## Customer Service Bulletin Commercial Business Group

### Reelmaster® 335-D/3500-D

**Subject: Peugeot Injection System interchangeability information.**

Injection Pump Identification  
Figure 1

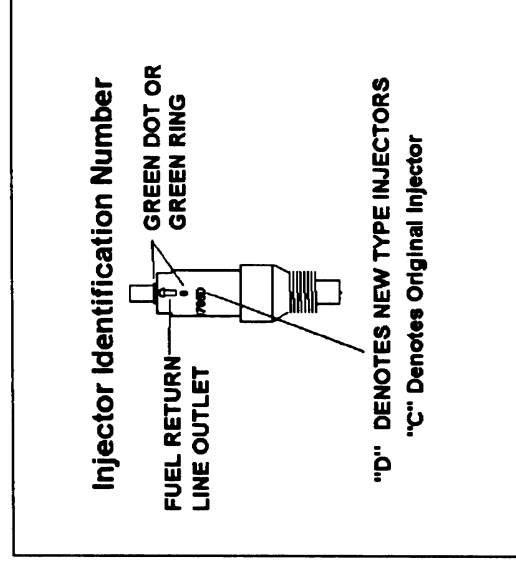
Original System	Injector Pump Identification	Injector Pump Interchangeability	Injector Nozzle Identification	Injector Nozzle Interchangeability	System Identification
<i>Toro Part Number</i>	<b>750A</b> (see Figure 1)	Can be used with a complete set of four "D" Injectors or four "C" Injectors only.	<b>C</b> (see Figure 2)	Use as a full set of four (4) only. Do NOT mix. Not recommended for use with 310A pump.	7mm hole located in the cylinder head. (See Fig. 3)
<i>Toro Part Number</i>	<b>310A</b> (see figure 1)	Use with "D" Injectors only. Not recommended for use with "C" Injectors.	<b>D</b> (see Figure 2)	Use as a full set of four (4) only. Can be used with either pump.	9mm hole located in the cylinder head. (See Fig. 3)
<i>Toro Part Number</i>

† If a 310A pump is installed on an older machine, new Mounting Bracket (74-8700) is required.
